Re: - Plot No 44.A12, Mucha Ambree

The Executive Land Manager & Architect
Karachi Municipality
Re - Plot No. 44 . A-12. Muchi Inianee Quater

— PLAN SHOWING PROPOSED HOUSE TO BE BUILT —

ON S. NO 44 A - 12 MAGHMEANI QR

GROUND FLOOR PLAN

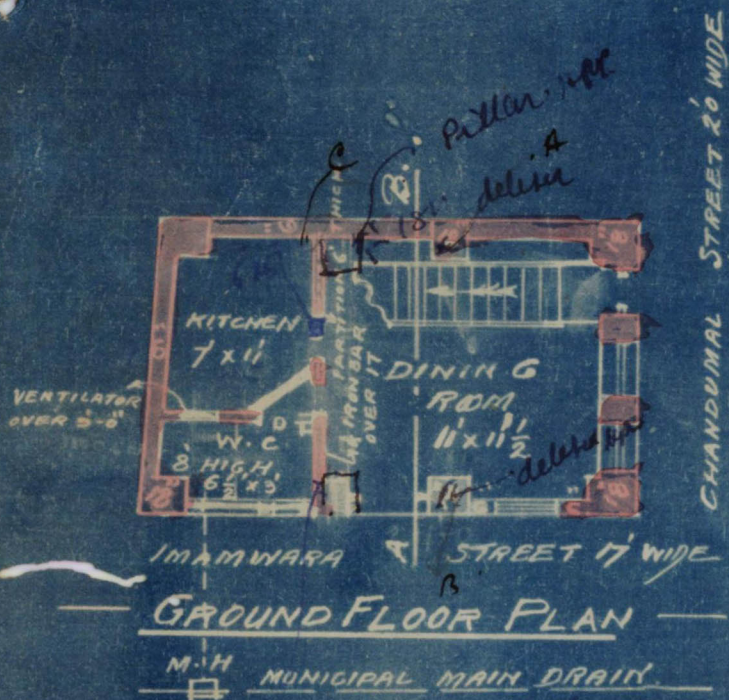
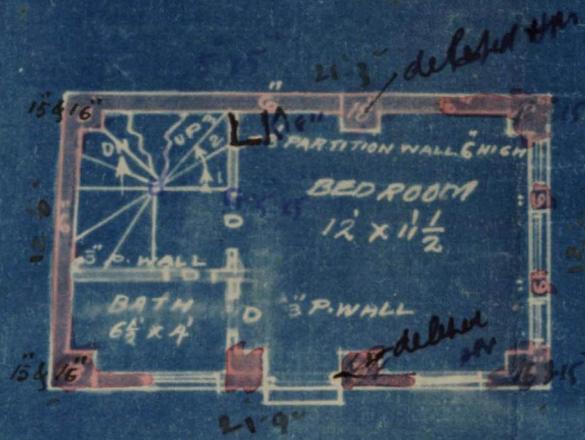
The applicant has
provided one C.B.
shell at the place marked
C and has own miter
two pillars marked
B and A.

After inspection the
construction, as going on site,
it seems that there is
no objection as the
exterior walls are made
9" thick miter of
6".

With reference to your letter no. G.M.A-3109 of the yesterday's date I have the honour to inform you that the pillars are constructed at internals as shown on the plan & moreover that the outside partition which was shown only 6" thick is made into 9" of c. concrete block to give additional strength.

This is done only for the ground floor. Here I am required to state that for the sake of having equal jambs to the door I had shown two pillars instead of one & that one which was additional put down for the sake of simitral appeal is dropped.

With reference to your letter No 1533 of the 7th inst regarding building on plot No 44, A-12, Muchi Mianee Quarter. I have the honour to state on behalf of my client *Mr* Chagla Valima Hamad, that the outer wall ^{of c.c. blocks} which was shown to be 6" thick on the ground floor is made 9" thick instead thereof, which means the wall is made stronger than proposed.

2. 1 pillar which was shown as a jar to the door for the sake of simitrical appearance is removed, which makes a change in the strength of building.

Instead of pillars 5" thick
 one has constructed over
 c. B. wall. Submitted if there is
 objection. 28/2/27

Had Pillars in the middle of wall are omitted — & such other minor deviation

informed that the building as erected differs from the approved plan.

With reference to his letter dated 21-2-27 ,
Mr. Hirashanker. P. Pathak on behalf of his client
Mr. Chagla Walimahomed in informed that walls less than
18" could be allowed only if pillars are constructed
at intervals. He is also requested to confirm to the
approved plans failing which action will be taken.

Instructions are therefore given to him to submit an amended plan for the building within 15 days from the receipt hereof, failing which, action will be taken under the Act.
